TECHNICAL INFORMATION  
FROM  
MARITIME SOLUTION GROUP

Subject : Information on software release (BDE-App version 02.23)

Equipment : JUE-501, Inmarsat FB500  
: JUE-251, Inmarsat FB250

Issue Number : SC-0004-19

Fig. 7.9.1.3 Tracking Setting screen

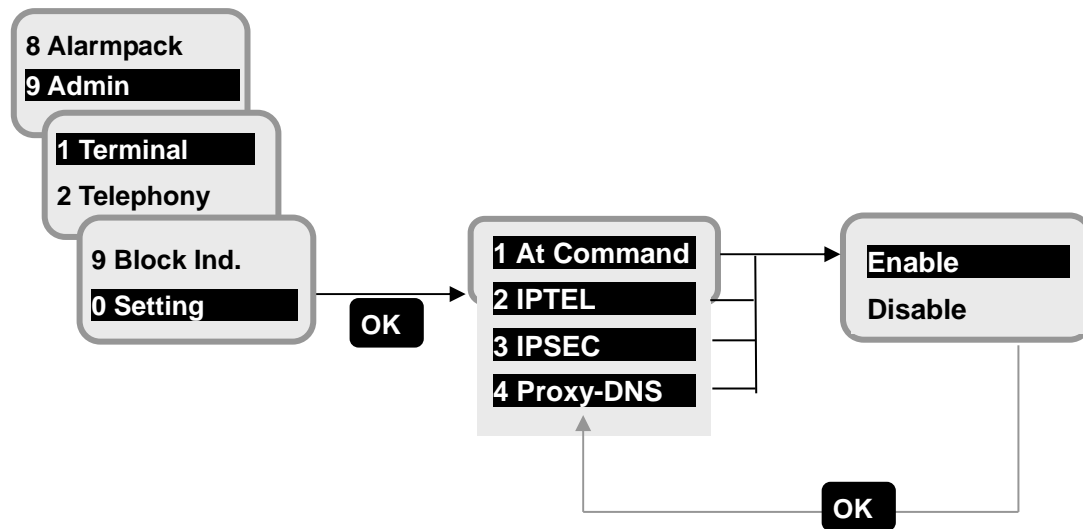
(2) Handset menu

In this menu, user can enable or disable AT command, IPTEL, IPSEC or Proxy-DNS function.

To change the setting, first, select the function by **▼▲** buttons and press **OK**. Next select Enable or Disable by **▼▲** buttons and press **OK**.

Fig. 6.5.1a Terminal Screen

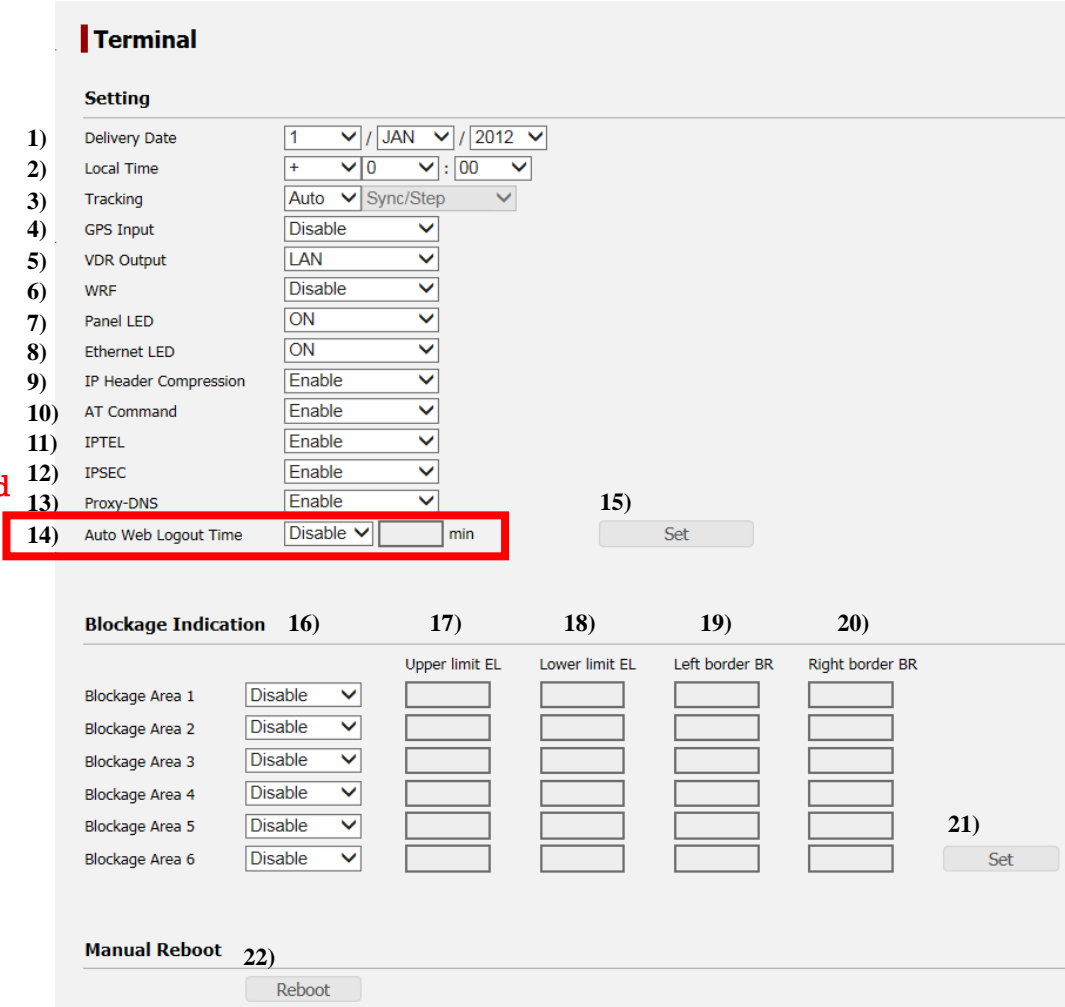
## Setting menu for Auto Web log-out function

The setting menu for Auto Web log-out function is added to Web menu (Admin – Terminal).

14)	Auto Web Logout Time	Enable or disable Auto Web Logout function When Enable is selected, the time (1 to 240 min) to logging out of Web menu automatically from last access is required.
15)	SET	Registers the setting contents
